AGENDA
Hailey Planning and Zoning Commission
Tuesday, June 20, 2023
5:30 p.m.

Meeting Minutes
Hailey Planning and Zoning Commission
Monday, June 5, 2023
5:30 p.m.

Hailey Planning and Zoning Commission

Ivie Studio Garage (9 Inch)
3rd Edition

FRONT ELEVATION
SCALE: 1/4" = 1'-0"

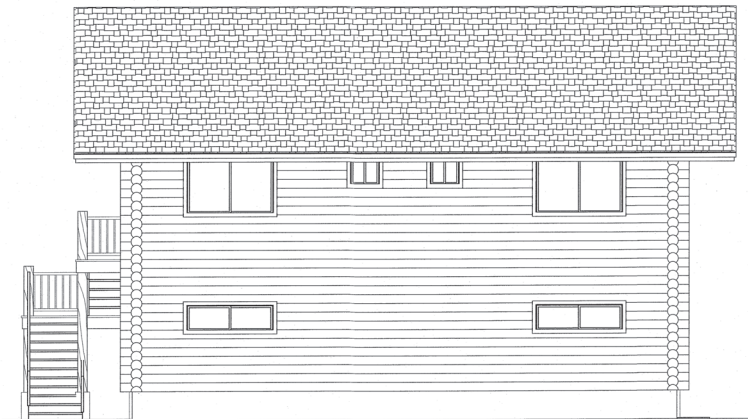
<input checked="" type="checkbox"/>	<input type="checkbox"/>	<input type="checkbox"/>	17.06.090(C)3f	f. Windows
				Guideline: Windows facing streets are encouraged to be of a traditional size, scale and proportion.
			<i>Staff Comments</i>	<i>The proposed windows are traditional in size, scale, and are appropriate for the neighborhood.</i>
<input checked="" type="checkbox"/>	<input type="checkbox"/>	<input type="checkbox"/>	17.06.090(C)3f	Guideline: Windows on side lot lines adjacent to other buildings should be carefully planned to respect the privacy of neighbors.
			<i>Staff Comments</i>	<i>A variety of windows are proposed and framed in a manner that is consistent with the neighborhood and do not impact neighborhood privacy.</i>
<input checked="" type="checkbox"/>	<input type="checkbox"/>	<input type="checkbox"/>	17.06.090(C)3g	g. Decks and Balconies
				Guideline: Decks and balconies shall be in scale with the building and the neighborhood.

<p><i>as opposed to monotone lap-siding.</i></p> 
<input checked="" type="checkbox"/>	<input type="checkbox"/>	<input type="checkbox"/>	<p>17.06.090(C)3h</p> <p>Guideline: Large wall planes shall incorporate more than one material or color to break up the mass of the wall plane.</p> <p><i>Staff Comments</i></p> <p><i>As shown below, the upper area of the top roof ridge incorporates an alternate shingle material, breaking up the mass of wall planes on 3 out of 4 elevations for the building.</i></p> 	
<input checked="" type="checkbox"/>	<input type="checkbox"/>	<input type="checkbox"/>	<p>17.06.090(C)3i</p> <p>i. Ornamentation and Architectural Detailing</p> <p>Guideline: Architectural detailing shall be incorporated into the front wall plane of buildings.</p> <p><i>Staff Comments</i></p> <p><i>Architectural detailing has been incorporated into the front wall plane of the proposed building, including features of alternating shingle, exposed log roof rafters, metal railings, and shaped windows to complement the entry gable (see below):</i></p>

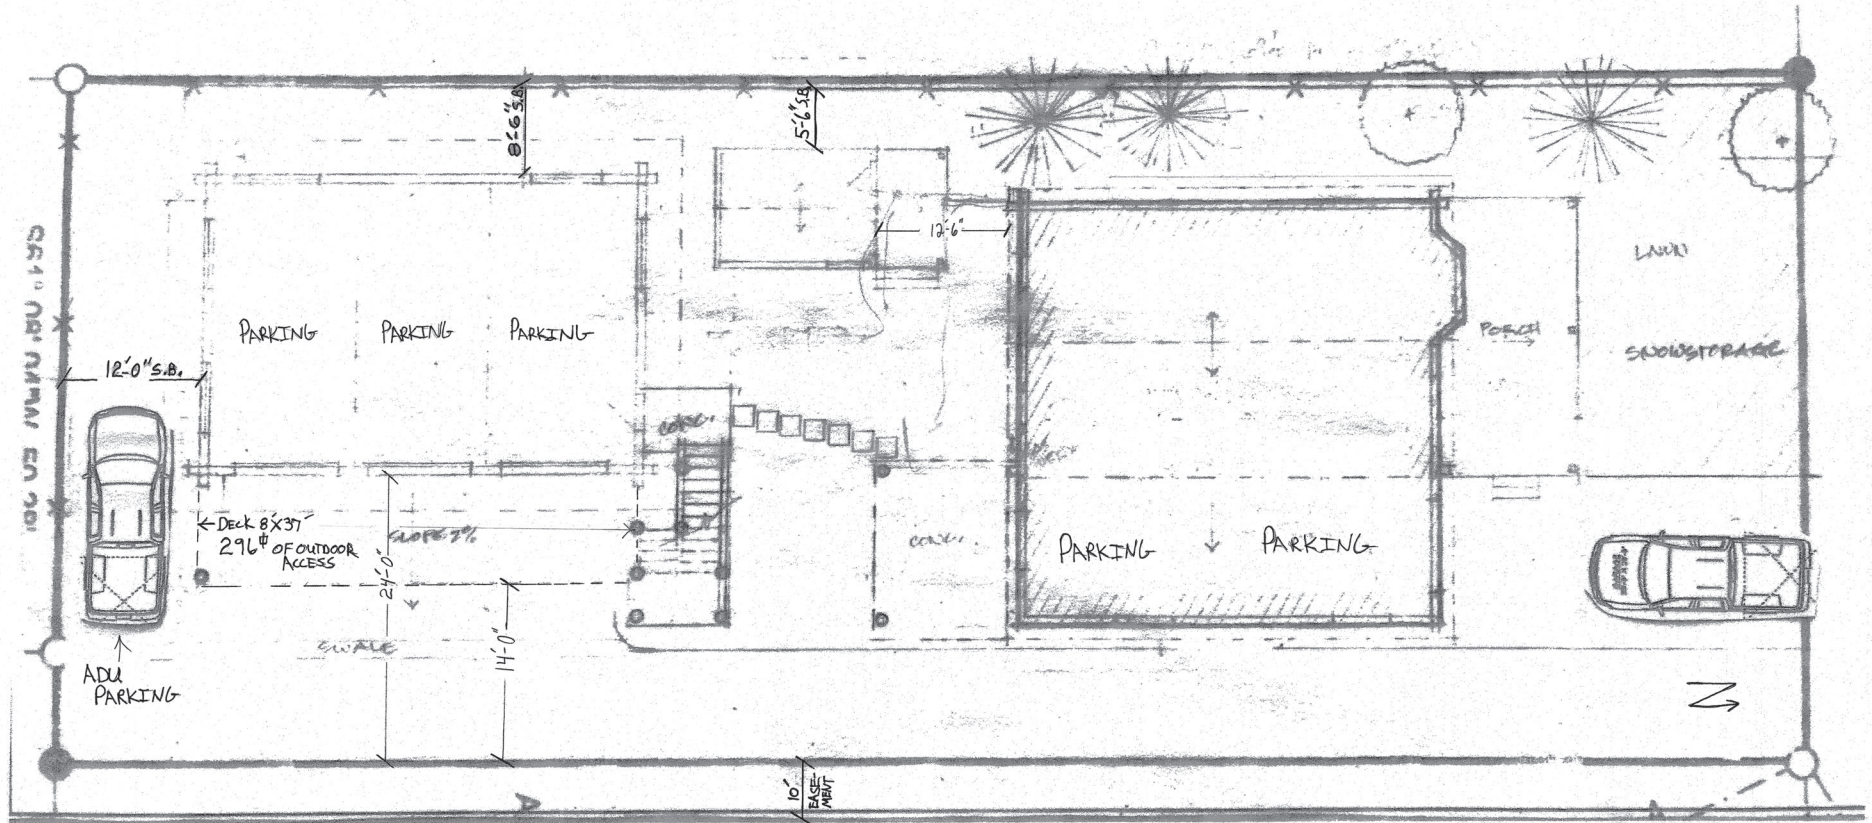
Staff Comments	<i>Submitted site plans do not show paved areas; however, outdoor parking areas are present and proposed. A snow storage area is shown on site plan in the northwestern corner of the lot, which appears to be adequately sized and placed to manage the volume of snow removal for the site. Dimensions were not provided by the Applicant.</i>
				<i>The Applicant may wish to provide an updated snow storage plan with paved surface /pedestrian walkway dimensions and dimensions of the snow storage</i>

area, complying with snow storage requirements as stated by Hailey Municipal Code, per the request of the Commission.
<input checked="" type="checkbox"/>	<input type="checkbox"/>	<input type="checkbox"/>	17.06.090(C)7	Guideline: A snow storage plan shall be developed for every project showing: <ul style="list-style-type: none"> • Where snow is stored, key pedestrian routes and clear vision triangles. • Consideration given to the impacts on adjacent properties when planning snow storage areas.
			<i>Staff Comments</i>	<i>Snow storage areas are located to the north and west of the parcel. Snow storage areas do not restrict pedestrian access. Pedestrian access is unrestricted and visible from the street.</i>
<input type="checkbox"/>	<input type="checkbox"/>	<input checked="" type="checkbox"/>	17.06.090(C)8	8. Existing Mature Trees and Landscaping Guideline: Existing mature trees shall be shown on the site plan, with notations regarding retention, removal or relocation. Unless shown to be infeasible, a site shall be carefully planned to incorporate existing mature trees on private property into the final design plan.
